Jordan Springs Public School

Detailed design road safety audit

Report No RC-PROJ-0001-01 DD RSA JORDAN SPRINGS REV 1

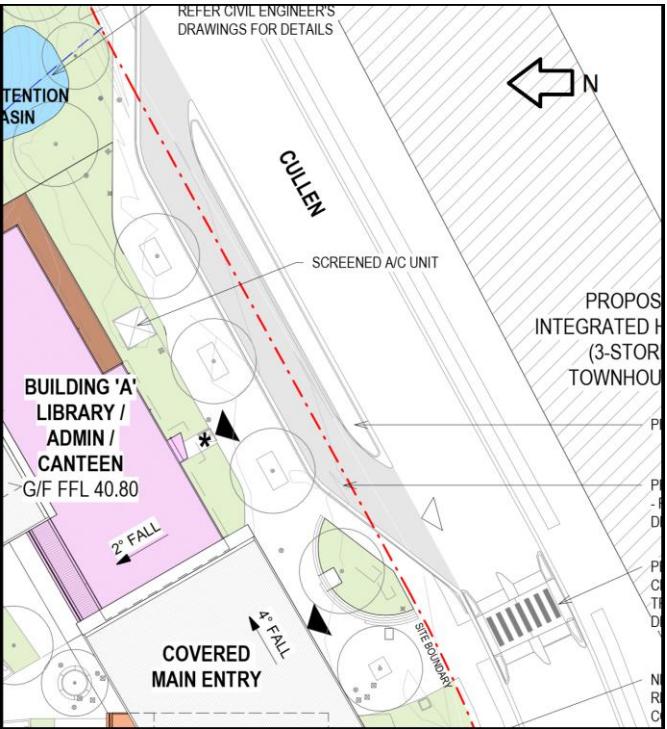
Ref	Location	Road safety audit finding	Priority
1	Pedestrian gates on Lakeside Parade.	<p>There are two pedestrian gates proposed on the Lakeside Parade frontage to the school – labelled X and Y below. These will inevitably generate pedestrian entry/ egress movements. These are also likely to generate demands for road-crossing movements in the midblock. These would mostly be uncontrolled crossing movements requiring the pedestrian to judge and select gaps in the northbound and southbound flows on Lakeside Parade. This would generate <i>vehicle-pedestrian</i> crash conflicts, particularly if school children are involved. Children tend to have poorer peripheral awareness and vigilance when crossing the road.</p> <p>The audit team appreciates that as this is a significant frontage length, pedestrian access points would be a reasonable amenity. As such, to a large extent, these midblock crossing demands will be inevitable. It should be noted that gates X and Y are approximately 200m and 110m (respectively) from the signalised crossing at the Cullen Avenue/ Lakeside Parade/ Water Gum Drive intersection. These distances would impose a severe time-penalty for pedestrians, especially those heading to Crimson Street, Landsborough Street and Pitt Street, as well as the northern portions of Lakeside Parade.</p> <p>The school would need to manage these risks with access-egress strategies and policies. The outbound movements would be relatively easy to manage under teacher supervision. However, the inbound movements involving crossing movements from the western side to the eastern side of the road would be more difficult to prevent. Concepts such as one-way (outbound only) gates could be considered. Alternatively, the gates could simply be locked when there is no ground supervision.</p>  <p>Above: Two pedestrian gates are proposed on the Lakeside Parade frontage which are likely to generate pedestrian crossing demands at these points.</p>	Medium

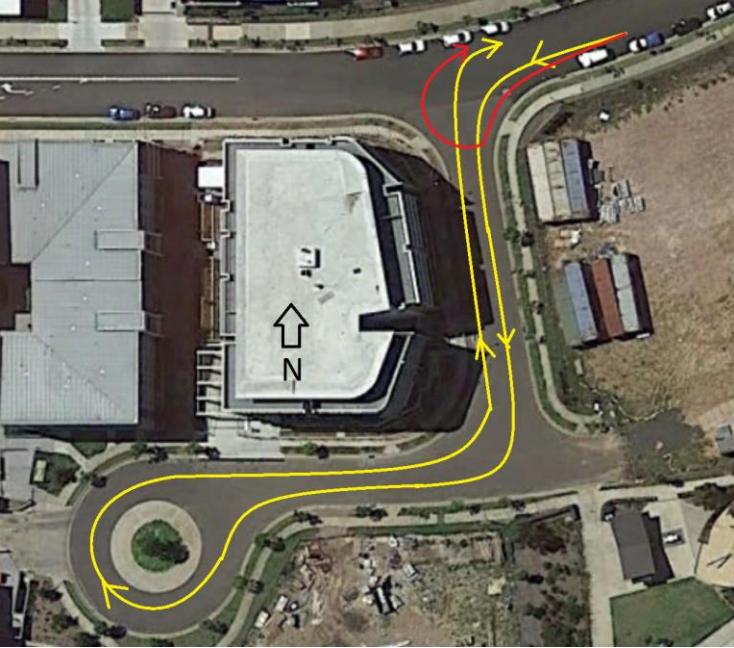
Ref	Location	Road safety audit finding	Priority
2	<p><i>Vehicle-pedestrian</i> conflicts at the driveways on Lakeside Parade and Cullen Avenue.</p>	<p>The design shows a staff car park on the eastern side of Lakeside Parade and a special needs car park and drop off area on the northern side of Cullen Avenue. Both of these facilities will have inbound-outbound driveways connecting to Lakeside Parade and Cullen Avenue respectively. As the project is still in design phase, there are several opportunities to reduce <i>vehicle-pedestrian</i> conflicts at the driveways.</p> <p>The audit team envisages that the Jordan Springs Town Centre will be a major attractor-generator of pedestrian trips to and from the school. Any pedestrian that emerges from the Lakeside Parade gate and heads towards the Town Centre would need to cross the staff car park driveway as shown by the blue line below. The same applies for the inbound trip in the reverse direction. This presents unnecessary conflicts with vehicles entering and egressing from the driveway. This is especially a risk when there are northbound right-turn movements into the driveway. These drivers would tend to look to the north to check for gaps in the southbound traffic stream and by doing so, may not observe pedestrians walking across the driveway. If there was also a pedestrian gate to the south of the car park driveway (eg. along line A-B-C), this could possibly eliminate such conflicts.</p> <p>Similarly, any pedestrians that emerge from the southern side of the school and head towards the Town Centre would tend to follow the green line. This passes through the special needs car park and driveway. There could be similar <i>vehicle-pedestrian</i> crash risks at this location as well. Similar to above, consideration could be given to providing a pedestrian access along the line A-D-E.</p> <p>Along the same theme of avoiding driveway conflicts, the plan below shows that the 44 bicycle parking spaces would be joined to the staff car park. As such, these cyclists would need to share the driveway with road vehicles which presents unnecessary <i>vehicle-bicycle</i> crash conflicts. Consideration should be given to linking the bicycle parking facility to the adjacent pedestrian walkway. This is indeed the layout shown on plan C04.01.</p>  <p>Left: Extract from the design showing the likely pedestrian walk-trip paths from the western and southern sides of the school due to the large attraction/ generation potential of the Jordan Springs Town Centre.</p>	Medium

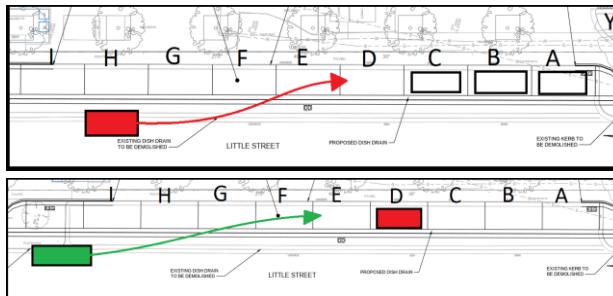
Ref	Location	Road safety audit finding	Priority
3a	Stopping/ parking restrictions on the kerblines – Lakeside Parade at the staff car park.	<p>The plans do not indicate whether there will be any <i>no stopping</i> zones along the Lakeside Parade and Cullen Avenue kerblines. Some critical locations were identified including the staff car park on the eastern side of Lakeside Parade, the special needs car park on the northern side of Cullen Avenue, and the pick up/ drop off bay on the northern side of Cullen Avenue. These have been discussed separately in items 3a, 3b and 3c.</p> <p><u>Staff car park on the eastern side of Lakeside Parade</u></p> <p>The staff car park will inevitably generate southbound left-turn movements, and northbound right-turn movements by inbound traffic. Southbound left-turners would tend to slow down when approaching and turning into the car park. If the eastern kerbline allows vehicles to stop or park, then the left-turning vehicle would need to commence the turn from a more central position in the road. This offers little passing opportunity for trailing southbound vehicles. By contrast, if a short <i>no stopping</i> zone is put in place along the eastern kerbline, the left-turning vehicle (red vehicle marked X) could shift to the kerbline and allow trailing vehicles to pass around as indicated by the blue arrow. As such, a <i>no stopping</i> zone should be considered on the eastern kerbline.</p> <p>Similarly, if northbound right-turners (red vehicle marked Y) stop to wait for gaps, any vehicles stopped along the western kerbline would restrict any passing opportunity by other trailing northbound vehicles. If a short <i>no stopping</i> zone is put in place on the western kerbline, trailing southbound vehicles could then use this space to pass around the stopped vehicle (green arrow).</p> <p>The above two scenarios illustrate the value of <i>no stopping</i> zones to improve passing clearance and to reduce <i>rear-end</i> crash potential. Short lengths of <i>no stopping</i> zones either side of the car park driveway would also help to preserve sight lines from the driveway to the north and south. Students and pedestrians moving along the eastern footpath and car park driveway would be less likely to be obscured by parked cars, and hence would be more visible to any drivers turning into the driveway.</p>   <p>Left: Extract from the design showing the criticality of passing opportunities on Lakeside Parade at the staff car park. This could be improved by implementing short lengths of <i>no stopping</i> zones on the eastern and western kerblines. Right: Looking southbound along Lakeside Parade from Crimson Street. Note the kerbside parking demand under pre-existing conditions.</p>	Medium

Left: The proposed layout of the pick up/ drop off bay.

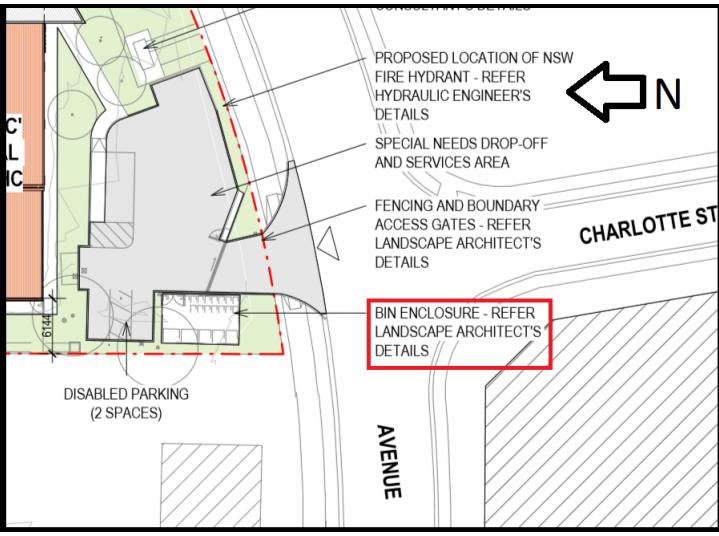
Ref	Location	Road safety audit finding	Priority
4a	Operational impacts of the pick up/ drop off bay on the northern side of Cullen Avenue.	<p>There are likely to be significant queuing and queue-related road safety impacts due to the pick up/ drop off bay. This would be especially during afternoon pick up periods following each school day. The audit team notes the following:</p> <ul style="list-style-type: none"> It is assumed that the pick up/ drop off bay will be a one-way <i>eastbound only</i> traffic lane and that all entry would be via the western opening and all egress will be via the eastern opening. Signs and pavement markings should be included, as appropriate, to stipulate this one-way rule and to prohibit entry into the eastern opening. The pick up/ drop off bay is configured as a <i>left-in only</i> access at its western end and a <i>left-out only</i> egress at its eastern opening. This is considered a reasonably safe layout assuming that all drivers comply with these turn restrictions. Signs and pavement arrows (as appropriate) should be considered to prohibit right-turns into or out of the pick up/ drop off bay. The westbound right-turn into the western opening would be a sharp hairpin turn. Some vehicles may not be able to perform this as a single manoeuvre and may need to resort to three-point turns (including a reversing adjustment with associated crash risks). The right-turn entry movement to the western opening could be a tempting movement since any vehicles that approach from the east would have very few other practical methods of turning around (see item 4b). By contrast the prohibited outbound right-turn movement (from the eastern opening) could be replaced by a left-turn out, and a u-turn at the Alinta Promenade roundabout (further east). <p>Continued in item 4b...</p> 	Medium

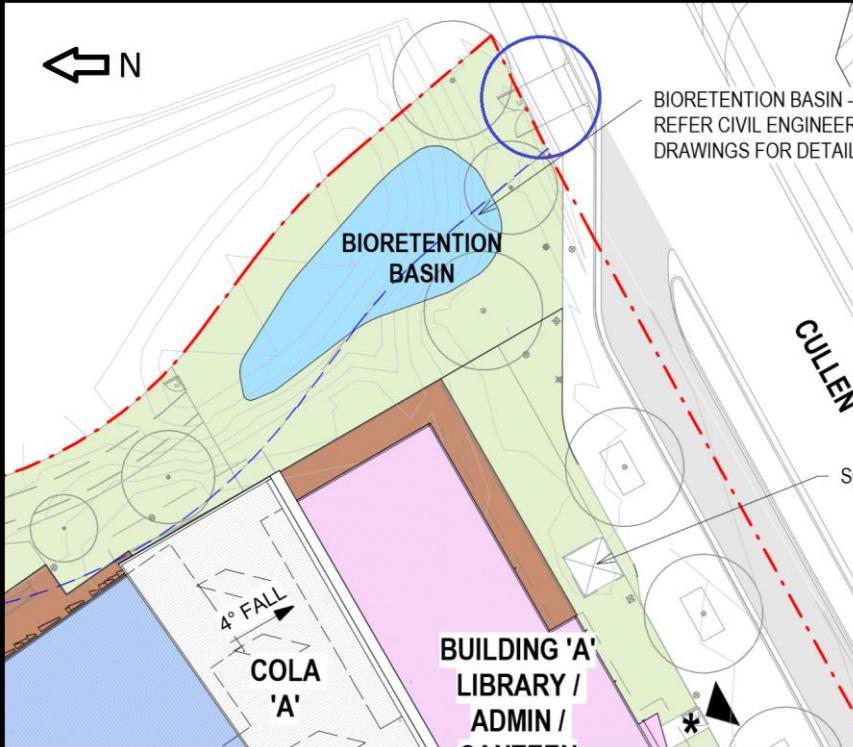
Ref	Location	Road safety audit finding	Priority
4b	<p>Operational impacts of the pick up/ drop off bay on the northern side of Cullen Avenue.</p> <p>Continued from item 4a...</p>	<p>Continued from item 4a...</p> <ul style="list-style-type: none"> As described in item 4a, the pick up/ drop off bay is configured as a <i>left-in only</i> access at its western end, and a <i>left-out only</i> egress at its eastern end. The inhibited right-turn entry movement at its western end may generate "q-turns" at the Cullen Avenue/ Charlotte Street intersection (ie. a westbound left-turn into Charlotte Street, followed by a u-turn, and followed by a right-turn back into Cullen Avenue such that the entire movement resembles a "q"). Typical "q-turn" movements are illustrated below – including a short "q-turn" along the red path and a longer version illustrated by the yellow path. Both of these will generate right-turn movements from Charlotte Street. This would generate crash conflicts with westbound and eastbound vehicular movements on Cullen Avenue. Typically, right-turns from the minor leg of intersections are the most difficult turning manoeuvres since there are gap acceptance (and hence gap-checking) requirements in both major road flows. The short "q-turn" path illustrated by the red arrow also introduces a u-turn in the control area of the intersection which could have its own crash conflicts such as with vehicles turning into or out of Charlotte Street. Consideration may be needed for signposted time-based prohibitions (bans) on right-turns from Charlotte Street during school zone periods.  <p>Left: With no other restrictions in place, the audit team envisages that Charlotte Street will be used by westbound drivers to perform "q-turns" to access the pick up/ drop off bay in lieu of the likely prohibited right-turn entry to the bay.</p>	Medium
